## Product Change Notice (PCN)

**PCN Number:** PCN-0451152R-01

**Product(s) Affected:** PJ-038A, PJ-038B, PJ-038AH, PJ-038BH

Current version	New version
Outlook		
Front	<p>without chamfer</p> 	<p>with chamfer</p>

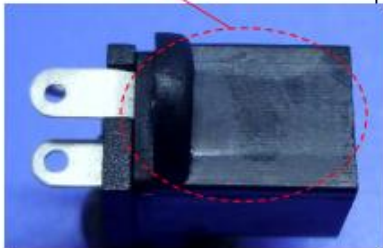
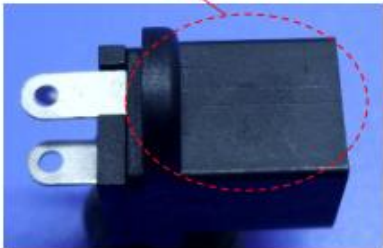
**Description of Change:** Thickness of pin 2 changed from 0.2mm to 0.25mm. Aesthetic changes as shown in below comparisons:

<p>Back</p>	<p>cave marking location</p>  <p>cave marking location</p>	<p>cave marking location cave marking location</p> 
<p>Top</p>	<p>without injection mark</p>  <p>thickness of pin#2 is 0.2mm</p>	<p>with injection mark</p>  <p>thickness of pin#2 is 0.25mm</p>
<p>Bottom</p>	<p>rough surface with injection mark</p> 	<p>smooth surface with injection mark</p>

Right	<p>rough surface</p>  <p>A photograph of a black cylindrical component with a metal tab on the right. A red dashed circle highlights the surface of the tab, which appears rough and textured. A red arrow points from the text 'rough surface' to this area.</p>	<p>smooth surface</p>  <p>A photograph of the same component as in the previous image. A red dashed circle highlights the surface of the tab, which appears smooth and uniform. A red arrow points from the text 'smooth surface' to this area.</p>
Left	<p>rough surface</p>  <p>A photograph of the component from a left-side perspective. A red dashed circle highlights the surface of the metal tab, which appears rough and textured. A red arrow points from the text 'rough surface' to this area.</p>	<p>smooth surface</p>  <p>A photograph of the component from a left-side perspective. A red dashed circle highlights the surface of the metal tab, which appears smooth and uniform. A red arrow points from the text 'smooth surface' to this area.</p>
